## SERVICE BULLETIN

**NUMBER:** 15-236-18R

**SUBJECT:** Reprogramming File Availability for Optimization of Harman Gen 3.1 and Gen 3.1α Audio and Navigation Head Units

**NOTE 4:** Displaying Repair Facility POI icons:

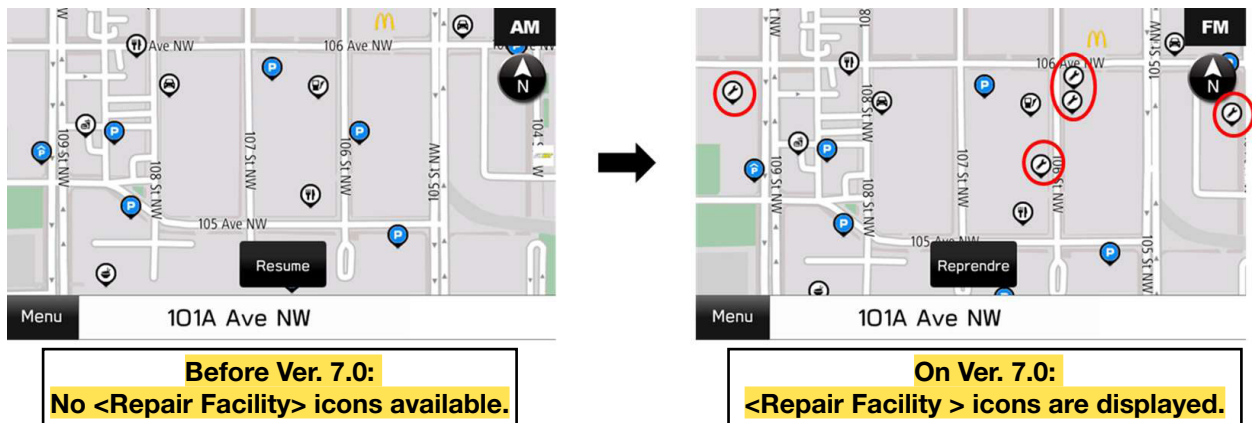
- 7) When an iPhone (CarPlay allowed) is connected using USB, the system moves to CarPlay screen no matter what is set in the <Auto Show Connected Device> menu in Setting. The Setting menu of <Auto Show Connected Device> is applicable only on Android Auto. See **NOTE 3** below.
- 8) Repair Facility POI icons are now shown on the NAVI map display. See **NOTE 4** below.

<Repair Facility> Icons can be displayed in the NAVI Map.

<Repair Facility> Icons can be turned On or OFF by going to: Settings > Navigation > POI Icons.

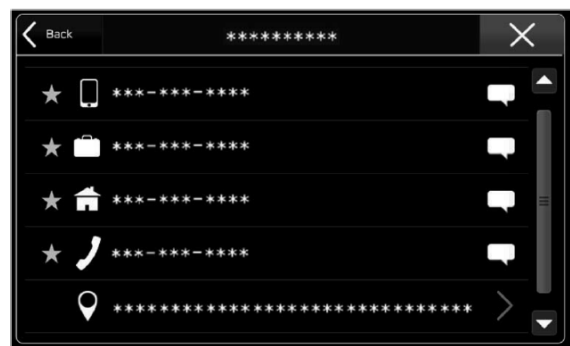
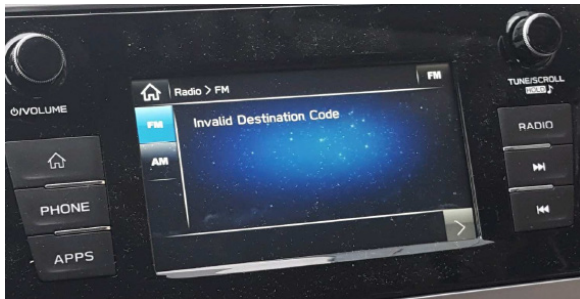
<Scan> previously displayed on SXM screen was changed to <Tune Scan> (a.k.a. SEEK).
